TOWN OF YARMOUTH
200 Main Street, Yarmouth, Maine 04096
www.yarmouth.me.us

Planning Board Report
Railroad Square Master Plan
Concept Plans for Development Plan & Major Subdivision
Railroad Square Associates, LLC, Applicant
Map 37 Lots 28 and 29A; CD-4 Village Center Character District
Prepared by Erin Zwirko, Director of Planning and Development
Report Date: March 3, 2022; Planning Board Date: March 9, 2022

Conceptual Railroad Square Master Plan

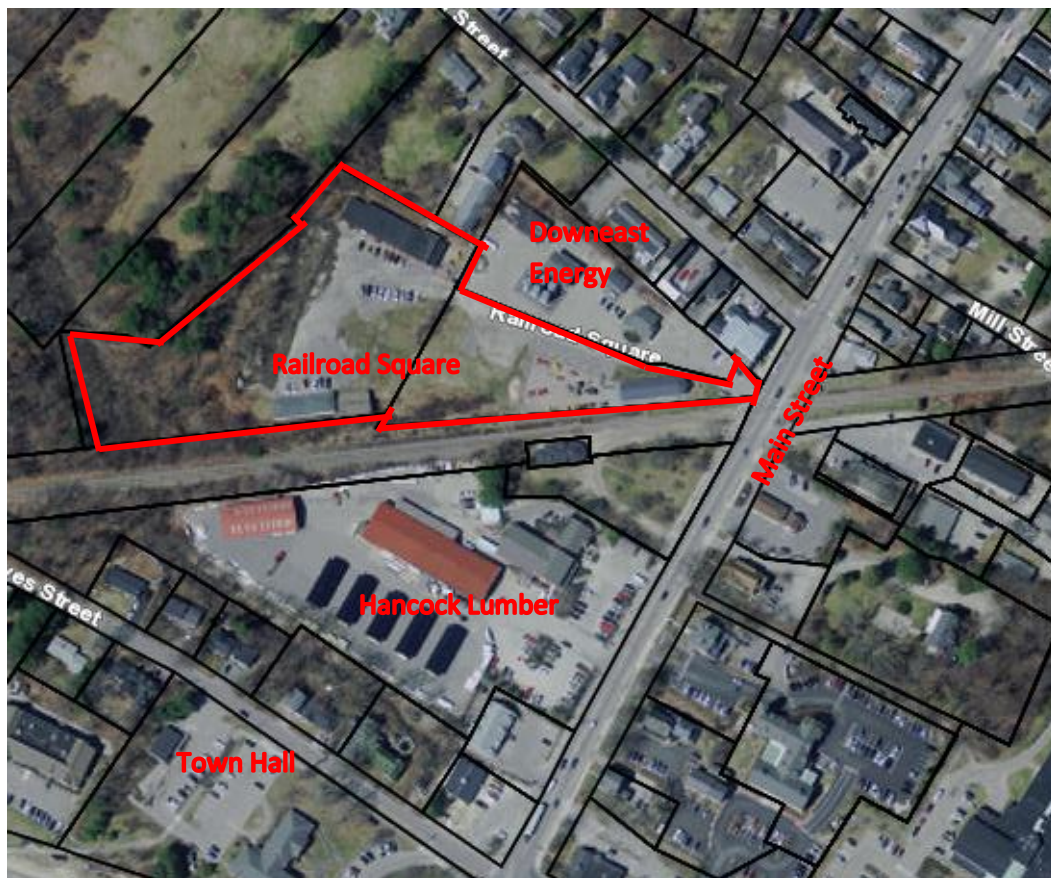
The meeting on March 9, 2022, is the second meeting with the Planning Board, and the first meeting on January 12, 2022 was an introductory meeting. Conceptual information is likely acceptable, but as the review becomes more detailed, more detailed plans and an assessment of compliance with the applicable standards will be required from the applicant. In the sections that follow, the staff has provided the initial assessment for the Planning Board's consideration, but in summary, the applicant will be required to provide more detailed information, in particular, the Thoroughfare arrangement and sections that illustrate the pedestrian, bicycle, and vehicular accommodations and connections, public landscaping, public lighting, and the public frontages. The Thoroughfare arrangement and sections are particularly important in order to determine compliance with the Chapter 601, Subdivision. Additional details about Civic Spaces must also be provided. With these additional details, Town staff will be able to more fully assess consistency with the requirements of Chapter 703.

The applicant has identified the need for at least one waiver from the CBDC standards. A waiver of the Lot Frontage requirement may be required to accommodate the pre-existing condition on Lot 1 with the pavilion which requires 170 feet of frontage due to the size of the existing structure and lot shape. The staff support this minor waiver, and the Planning Board should provide feedback to the applicant on the request. Additional waivers may be identified as additional details are provided.

Railroad Square Pedestrian Shed

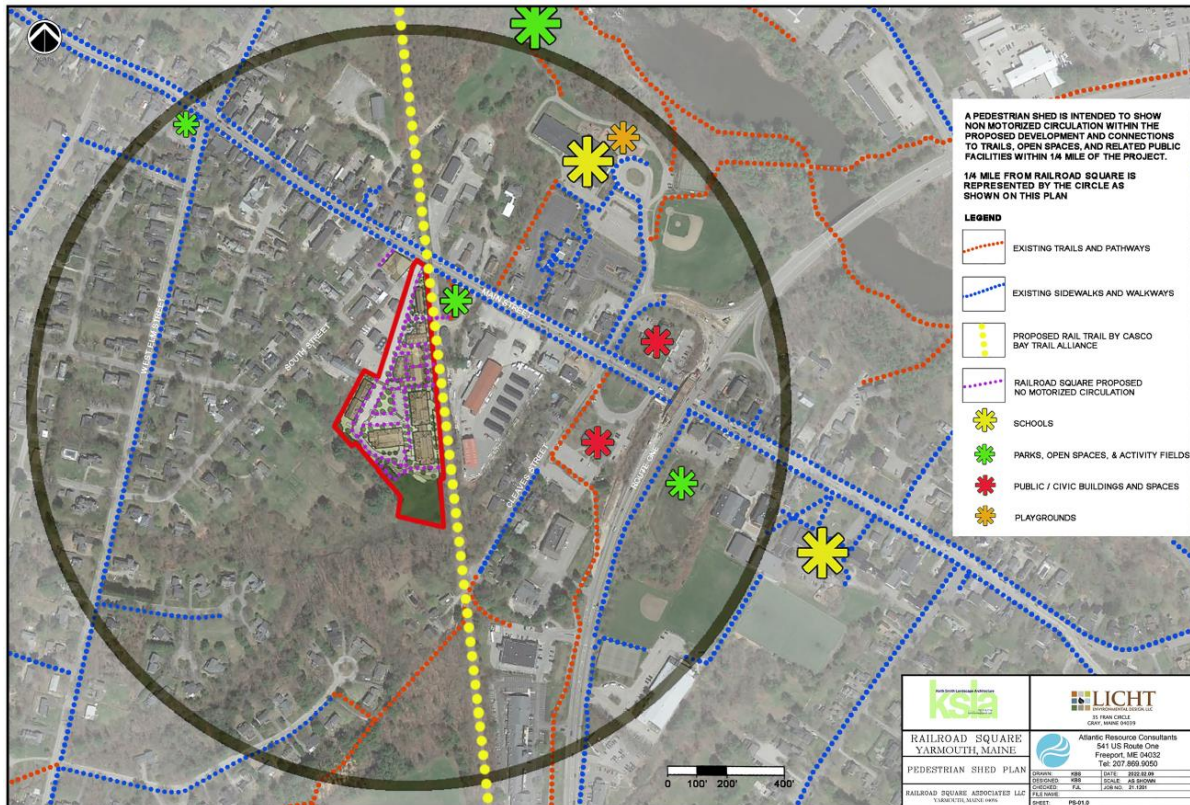
The staff agree with the applicant’s assessment and find the Pedestrian Shed illustration to be adequate, although may be missing some Common Destinations in the Village. Those locations that may be missing is the NYA Campus, the Route One bridge, the Log Cabin, trails within Royal River Park, 317 Main Music Center, the Community Center at the Masonic Hall, the Old Meeting House, the Center Street Island, and the Butterfly Park and Beth Condon Memorial. The Village is the heart of the community, and the proposed development will be well-connected to the existing network for pedestrians and bicyclists to access the Common Destinations present in the Village.
